Re: Fifth Set of Public Comments Submitted on Behalf of Fifth Ward Impact and Community Action ("Impact") and Anna Ortiz Regarding Draft Renewal Permit/Compliance Plan 50343 Authorizing Renewal of Hazardous Waste Permit.

Lone Star Legal Aid ("LSLA") submits this fifth set of comments on behalf of its clients, Fifth Ward Impact and Community Action ("Impact") and Anna Ortiz (collectively, "Commenters"), regarding Union Pacific Railroad Company's Draft Renewal/Compliance Plan 50343 ("the Draft Permit"). The Union Pacific Railroad Company ("UPRR") has applied to the Texas Commission on Environmental Quality ("TCEQ") for a permit renewal with a major amendment to authorize the continuation of the terms and conditions of the Permit and to submit the Response Action Plan ("RAP") to address the facility-wide and off-site soil and groundwater contamination. Union Pacific owns the Houston Wood Preserving Works Facility ("the Site") located at 4910 Liberty Road, Houston, Harris County, Texas 77026.

Map 1-October 2020 Map of PCLE Zone with Location of Impact Members' Residences

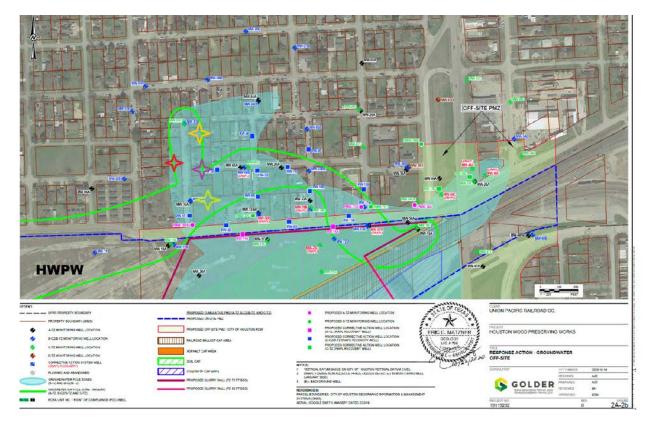
A few members of Impact live above the well-documented, though not fully characterized, groundwater plume which itself lies over a *deeper* creosote/DNAPL plume. Map 1 below (the original made by Golder, UPRR's contractor, showing the extent of the Protective Concentration Level Exceedance ("PCLE") Zone, among other things) presents a bird's-eye view of the affected residential neighborhood, surrounding residential blocks, and indicates the location of some of Impact's members' residences and/or properties. These members include:

- 1. Sandra Edwards who resides at 2925 Lavender Street, and is the owner of said property, which lies along the western edge of the previously proposed off-site plume management zone ("PMZ"), directly above the PCLE Zone, and less than a tenth of a mile from the UPRR Site. Ms. Edwards was born in 1965 and raised at the home on 2925 Lavender until 1985. She returned to live permanently in her childhood home in 2010. Ms. Chamesha Randall, Ms. Edwards' daughter, signed a restrictive covenant for this property on March 31, 2015, in the context of UPRR's attempt to comply with the then proposed remediation plan. Ms. Edward's property is represented by the red star on Map 1 below. Ms. Edwards is one of the spokeswomen and representatives of Impact and she may be contacted via Impact's counsel with LSLA, Rodrigo Cantú.

- 2. Leisa Harris-Glenn is the owner of 2924 Lavender Street, a property inside the previously proposed off-site PMZ, above the PCLE zone and less than a tenth of a mile away from the UPRR Site. She moved to the home in 1984 when she was 27 years old and lived there with her mother and son until about the year 2000. Although she no longer resides in the area she often returns to her old home to visit her brother and nephew who continue to reside at 2924 Lavender. Ms. Harris-Glenn signed a restrictive covenant for this property on June 27, 2015, in the context of UPRR's attempt to comply with the then proposed remediation plan. Ms. Harris-Glenn's property is represented by the purple star on the Map below.

- 3. Mary Hutchins resides at 2938 Lavender, a property inside the previously proposed off-site PMZ, above the PCLE zone and less than a tenth of a mile away from the UPRR Site. She has resided at this address for over 50 years. Ms. Mary Hutchins signed a restrictive covenant for her property on April 7, 2015, in the context of UPRR's attempt to comply with the then proposed remediation plan. Ms. Hutchins' property is represented by the gold star on the Map below.

- 4. Barbara Beal who resides at 2906 Lavender Street and is the owner of said property which is located within the previously proposed off-site PMZ and less than a tenth of a mile from the UPRR Site. She came back to live in her family home in January of 2009 and has lived there ever since. Prior to that, she had lived in the same home off and on since the 1950s. Ms. Beal signed a restrictive covenant for her property on February 19, 2015, in the context of UPRR's attempt to comply with the then proposed remediation plan. Ms. Beal's property is represented by the green star on the Map below.
